Date of Transmission: 2/6/2018 Project: John Hardin High School

Project Number: 201374

Change Order

PROJECT (Name and address):	CHANGE ORDER NUMBER: 003	OWNER:
John Hardin High School	DATE: 12/21/2017	ARCHITECT: ☐
Improvements to Minor Athletic Facilities	Revised: 02/06/2018	CONTRACTOR:
TO CONTRACTOR (Name and address):	ARCHITECT'S PROJECT NUMBER: 2016133	FIELD:
Congleton-Hacker Company	CONTRACT DATE: 06/07/2017	OTHER:
872 Floyd Drive	CONTRACT FOR: General Construction	OTHER.
Lexington, KY 40505		
Change Proposal 8: Per RFI #12 respon	amount attributable to previously executed Co	" x 8" transfer air grille for the restroom side
Total cost of change proposals is \$1,777	2.40.	
The cost of this change order shall be ta	aken from Allowance No. 1.	
Allowance No. 1 = \$25,000.00		
CO #1 - \$6,820.18		
CO #2 - \$804.20		
Remaining Allowance = \$17,372.62 CO #3 - \$1,772.40		
Remaining Allowance = \$15,600.22		
Cancel out remaining Allowance No. 1	balance of \$15,600.22	
The original Contract Sum was The net change by previously authorized Ch The Contract Sum prior to this Change Orde The Contract Sum will be decreased by this The new Contract Sum including this Change	er was Change Or

RFI #012

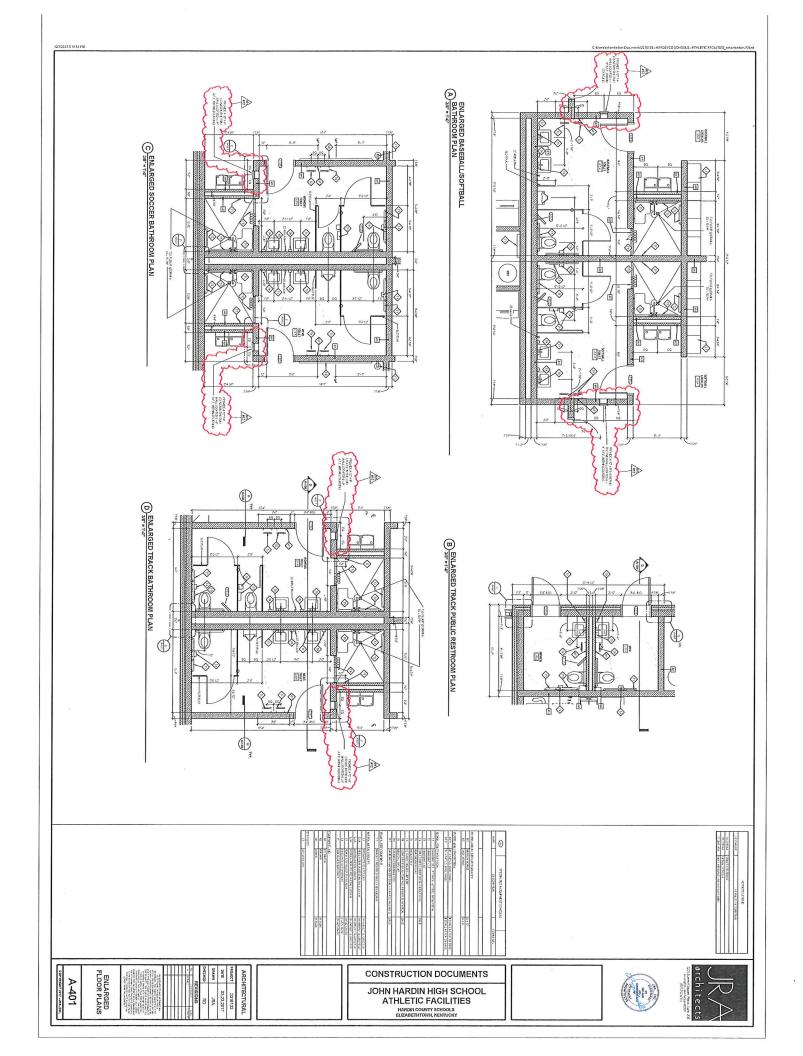
TO: JRA		: John Hardin HS Athletic Improver
FROM: Congleton-Hacker Company	Ref.:	Toilet Rooms
In Reference To:		
QUESTION:		
See the question and suggestion from Lusk.		
. "		
Cionad. Will Conton		se Schedule/Cost se Schedule/Cost
Signed: Will Carter By	No Cha	
Date: 12/5/2017		wn at This Time
Response Neede		12/6/2017
ANSWER:		. '
Provide Price model number 700, 10 the restroom side and locker room sin the attached draw	ide in t	he locations indicated
Answered by:	Procee	d at no cost to the Owner.
		d and submit pricing.
Signed: Craig Chamberlain		pricing w/in 14 days.
By: 12.07.2017	Do No	t Proceed.
Date: 12.07.2017

Request For Information			
Project: John Hardin High School Athletics Facilities			
RFI Title: Louvers Date: December 5, 2017			
Originator: _Jeremy Hester			
Subject: <u>Louvers</u> Category <u>HVAC</u>			
Sent To: Will Carter			
Information Requested Date Required: ASAP The state HVAC inspector was on site yesterday. He informed us that there needs to be a way to get fresh air into the toilet rooms to make up for the exhausted 225 cfm.			
Suggestion: Since the block is installed, the simplest solution is to install a louved door. Please advise			
Response:			
Answered By:

Change Proposal 8: Per RFI #12 response, "provide Rice model number 700, 16" x 8" transfer air grille for the restroom side and locker room side in the locations indicated in the attached drawing A-401." (Total of twelve grilles.) (add of \$1,772.40)

This cost was generated from RFI-012. Cutting block wall and installing 12 louvers.
